ORIGINATION FORM

Proposed Revisions to a Standard Plans Index

Index Number: 102-110

Index Title: Type K Temporary Concrete Barrier System

ADHESIVE BONDED ANCHOR INSTALLATION

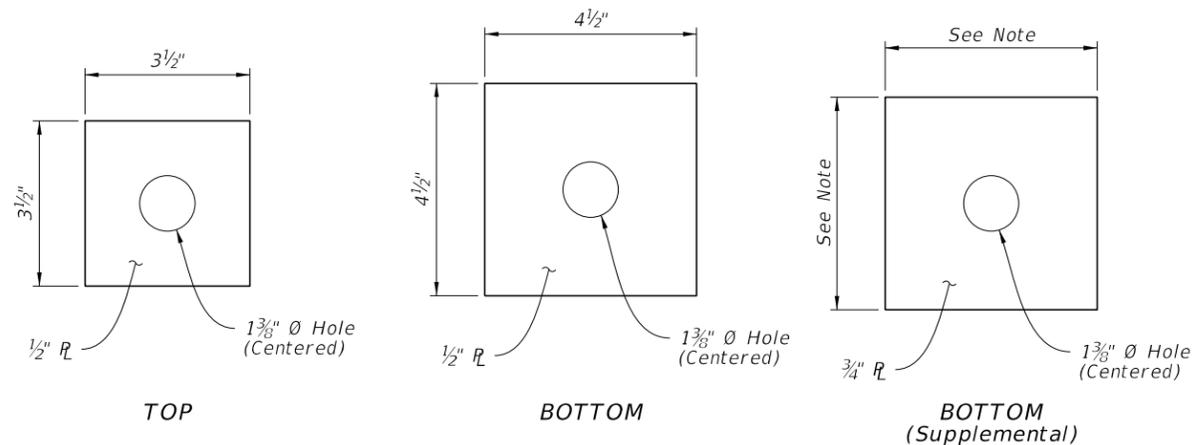
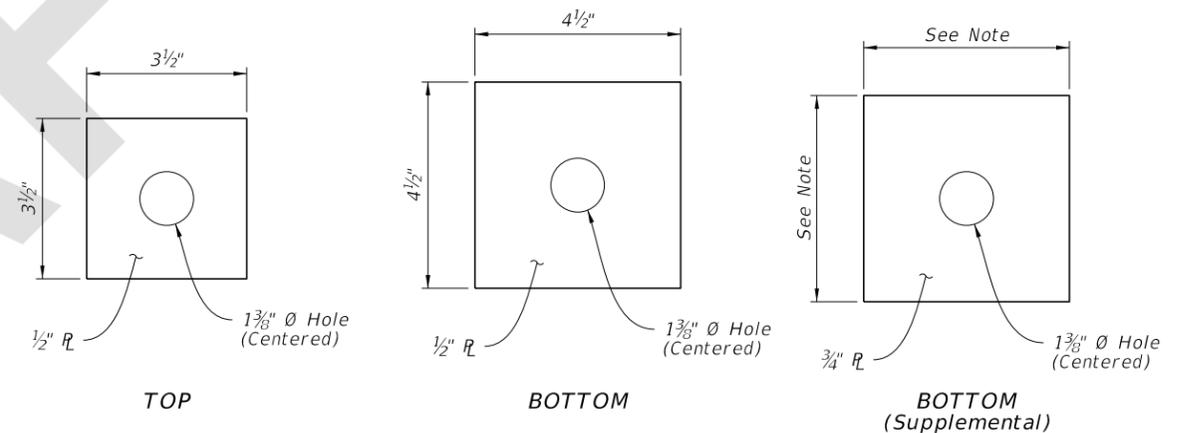
Sheet 2: Updated the ADHESIVE-BONDING MATERIAL SYSTEM Note to “When using adhesive bonding material systems for anchor bolts, use a Type HSHV adhesive meeting the requirements of Specification 937 and listed on the APL. Install anchor bolts in accordance with Specification 416. Field testing requirements of Specification 416 do not apply”.

Index 102-110 references Specification 416 for the installation and field testing of anchor bolts on temporary concrete barrier. The field test requirements of Specification 416 were discussed with Structures design and it was clarified that they were intended for permanent installations.

ADHESIVE-BONDING MATERIAL SYSTEMS: When using Adhesive Bonding Material Systems for Anchor Bolts, Use Type HSHV in accordance with Specification 937 and installed them in accordance with Specification 416. Prior to installation of the Barrier Units in the Plan location(s), install a demonstration Barrier Unit using the proposed production installation method, at a location approved by the Engineer. In lieu of the production test requirements of Specification 416, install six (6) Adhesive-Bonded Anchor Bolts in the demonstration Barrier Unit and test each Anchor Bolt with a 29,800 pound tensile proof load. Install and test additional demonstration Barrier Units when requested by the Engineer. Remove the demonstration Barrier Unit prior to testing the Anchor Bolts. Remove the test Anchor Bolts after testing as directed by the Engineer.

Updated Note to read "When using adhesive bonding material systems for anchor bolts, use a Type HSHV adhesive meeting the requirements of Specification 937 and listed on the APL. Install anchor bolts in accordance with Specification 416. Field testing requirements of Specification 416 do not apply."

ADHESIVE-BONDING MATERIAL SYSTEMS: When using adhesive bonding material systems for anchor bolts, use a Type HSHV adhesive meeting the requirements of Specification 937 and listed on the APL. Install anchor bolts in accordance with Specification 416. Field testing requirements of Specification 416 do not apply.
